SUBJECT: REQUEST FOR COMMENTS ON DRAFT NUREG/CR-5632,
"INCORPORATING AGING EFFECTS INTO PROBABILISTIC
RISK ASSESSMENT-A FEASIBILITY STUDY UTILIZING
RELIABILITY PHYSICS MODELS"

INCORPORATING AGING EFFECTS INTO PROBABILISTIC RISK ASSESSMENT-A FEASIBILITY STUDY UTILIZING RELIABILITY PHYSICS MODELS

Figure 1

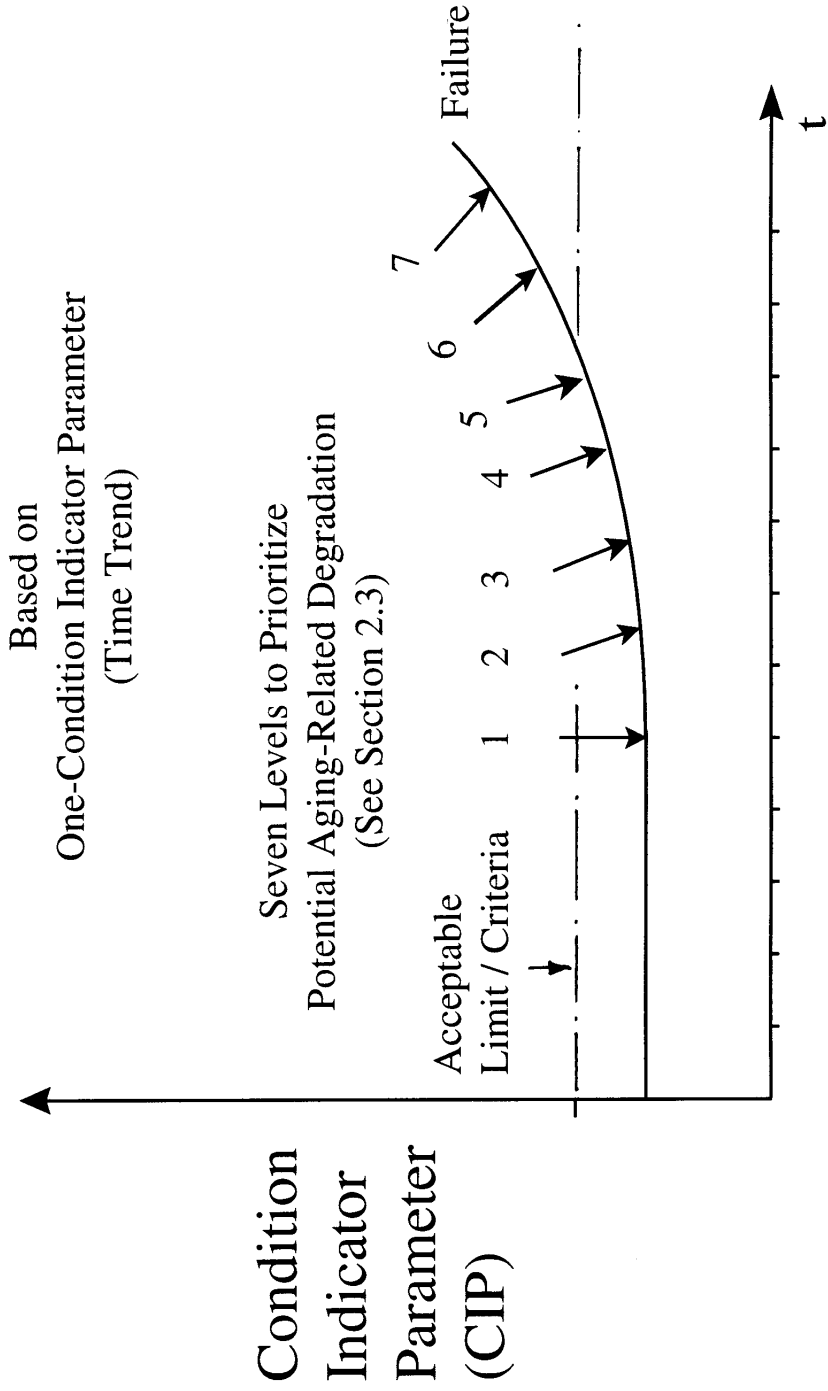
1. As a key element of the Aging Physics Model, it would be very useful to recognize and incorporate, how aging mechanisms and their detrimental effects are propagated over the service life of the component or structure? That is:

(a) determine significant Condition Indicator Parameter(s) (CIPs) relevant to the performance of the component or structure under study,

(b) how CIPs trend over the service life of the component or structure due to age-related degradation effects? (See Figure 1),

(c) establish acceptance criteria for the CIP value(s),

(d) prioritize potential age-related degradation effects, based on rate of change in CIP value(s) (See the 7 levels in Figure 1),

(e) establish probability of failures and uncertainties, based on time-trend of CIPs,

See General Comment and Figure1. It would be very useful to relate the seven levels of aging degradation in the context of wall thinning attributable to flow-induced corrosion and prioritize accordingly.
